NUREG-1560
Vol. 3

Individual Plant Examination Program: Perspectives on Reactor Safety and Plant Performance

Appendices A, B, and C

U.S. Nuclear Regulatory Commission

Figure C.1 Comparison of NUREG-1150 and Westinghouse seal LOCA models — old o-ring elastomer.

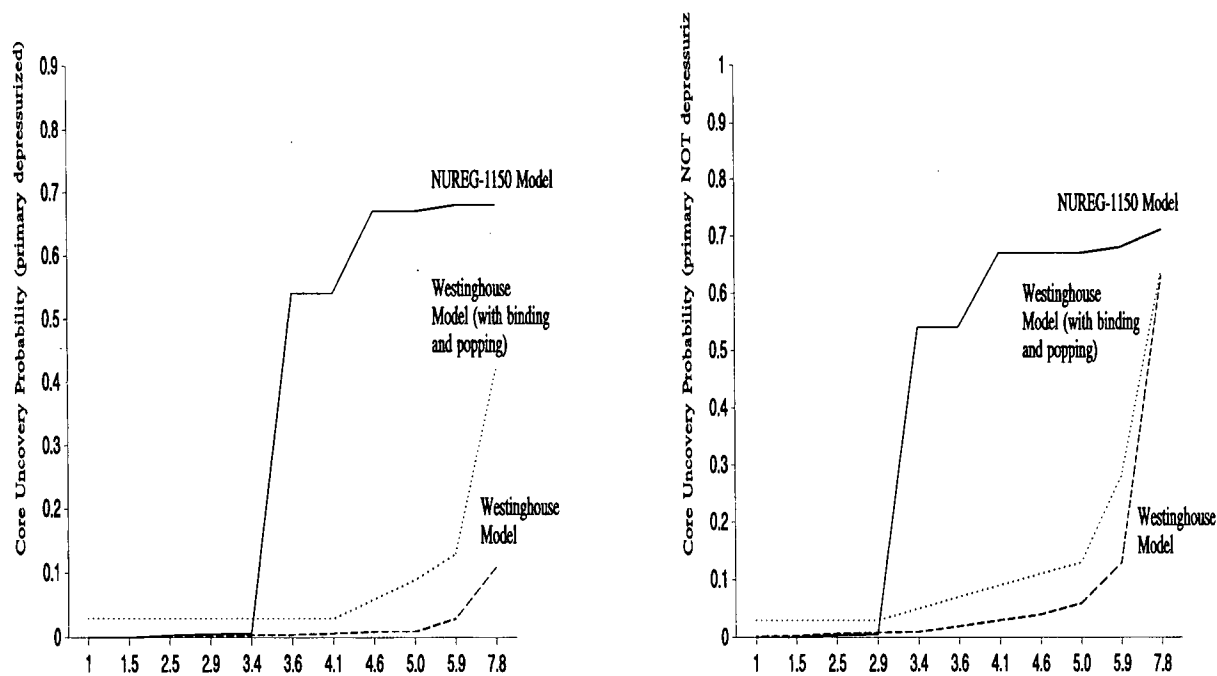
11. **Comment:** It is not clear from the information presented that the Westinghouse RCP seal LOCA model provides a lower contribution to CDF than the IPEs that used the NUREG-1150 model.

Since this is very important to many plants, it is recommended that NUREG-1560 provide a detailed comparison of the two approaches. One of the dominating factors in the seal LOCA model is the probability of core uncover occurring within the first hour. IPEs using the Westinghouse RCP seal LOCA model typically use 0.0283 and the NUREG-1150 model uses 0.0. The NUREG-1150 model does not consider any seal leakage for the first 90 minutes. From these facts it appears that the Westinghouse RCP seal LOCA model is more conservative. (Reference: see Table C.1, #16)

A comparison of the seal LOCA probabilities from the two models was not possible due to the unavailability of the reports documenting the Westinghouse model (with and without seal binding and popping open included). However, the Point Beach IPE and the response to questions concerning the Farley IPE did provide

an opportunity to compare the core uncover probability as a function of time for cases involving RCPs equipped with the old o-ring elastomer with the vessel either depressurized or not depressurized, and with the RCPs tripped. A comparison of the values from these curve fits with the core uncover times calculated for identical cases for the Surry plant, as reported in NUREG-1150, Volume 3, is provided in Figure C.1. The curve fit is only valid over the time frame of 30 minutes to 8 hours. It should be noted that Point Beach is a two loop plant

while Surry and Farley are three loop plants and thus the core uncover time for a given leak rate could be different. However, since the reactor coolant system volumes for the plants are roughly scaled by the number of coolant loops, the core uncover times for three plants for the same amount of leakage from each pump should not be substantially different. Thus, the core uncover probability comparison in Figures C.1 provides a reasonable picture of the differences between the NUREG-1150 and Westinghouse seal LOCA models.

Figure C.1 indicates that all three models predict small probabilities of leaks and core uncover for early times (less than about 3 hours). Because of this, differences between the three models do not have a significant impact on CDF for this early time period. However, for later times, the differences are more significant. The Westinghouse models generally predict much
